FIRE DEPARTMENT

Re: Installation of Hydrants and Water Main-
Torrice Loop Development
Staten Island, New York 10309
Block 7577 Lots 39-74 inclusive

Fire Prevention Index No. 1311034
Fire Prevention FPIMS No. 33274549

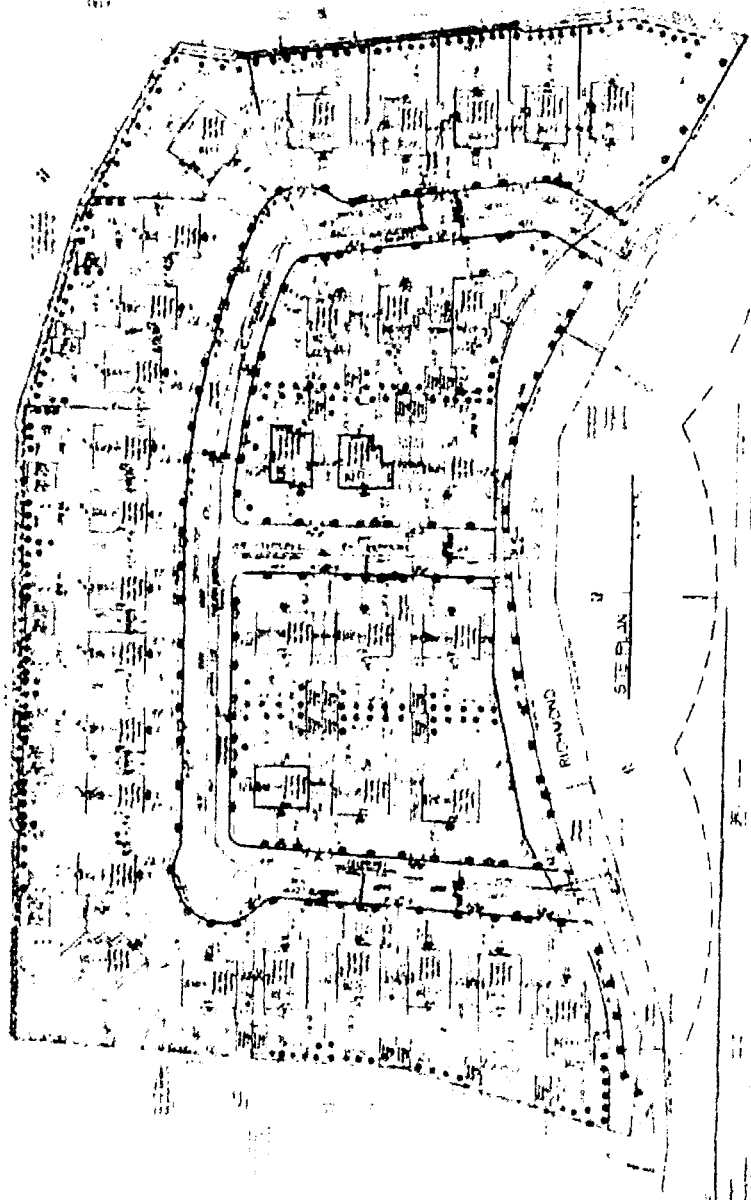
- Hydrants must be located within 250 feet of the entrance to each dwelling unit and hydrants must be on 8" or greater water mains.
- The height of the dwelling shall not exceed 35 feet above grade plane.

- As per Fire Code Rule 503.7. install and maintain NO PARKING signs at the entrance and along both sides of the fire access roads (The length of Torrice Loop and Frosinone Lane) where parking is **prohibited**. NO PARKING signs shall conform with the specifications of Fire Code Rule 503.7

- For this development which consists of a 34' wide fire apparatus access road all buildings must comply with the requirements of section 26-21 of the zoning resolution which states where at least three accessory parking spaces are provided for every two dwelling units and no such spaces are located within the bed of a private road, the minimum width shall be 34 feet, as indicated on the approved plan which is made part of this letter.
